P5021A-03A-S

Safety Service Note

P5021A Keysight Streamline USB Vector Network Analyzer

“POTENTIAL BURN INJURY (HIGH TEMPERATURE) HAZARD”

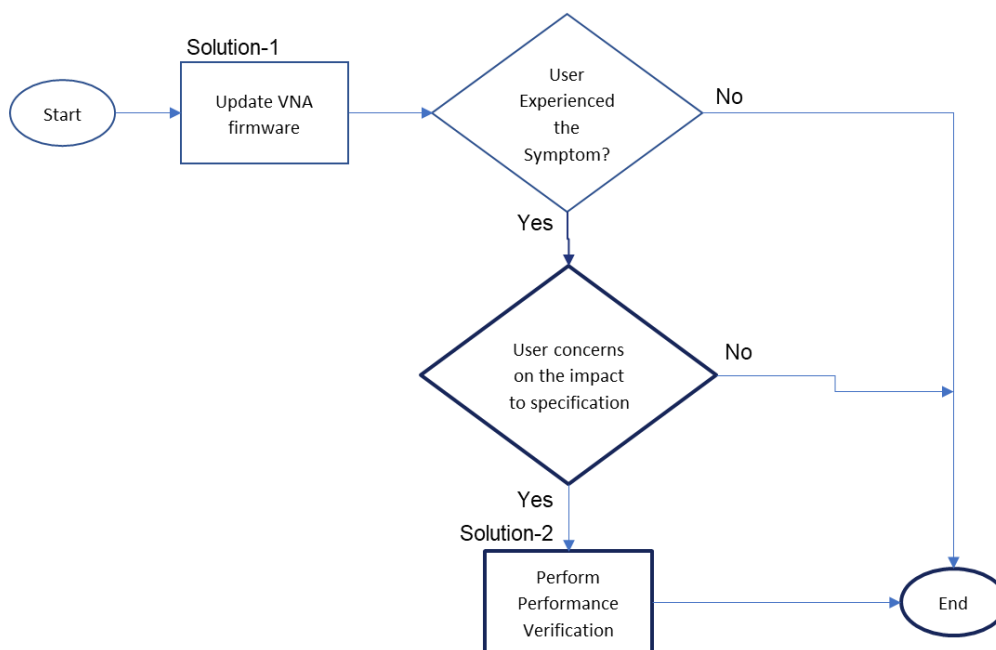
VNA fails to start with the following symptoms.

1. LED indicator (below circle) turns red.
2. cooling fan does not work
3. If user leaves the VNA with this LED indicator red without turning off power switch, it continues to overheat and becomes too hot.

Solution-1: Update VNA firmware by user

Action-1: Updating the firmware eliminates this potential risk of overheating.

1. **Install the latest VNA firmware Rev. A.15.55.14 or newer** on users' controller PC(s).
The latest firmware enhanced the thermal fan control mechanism.
2. Once the latest firmware is installed, proceed with the restart of both **controller PC** and **VNA**.
3. Launch the VNA firmware. Ensure VNA powers up and launches into firmware correctly after firmware update is done.
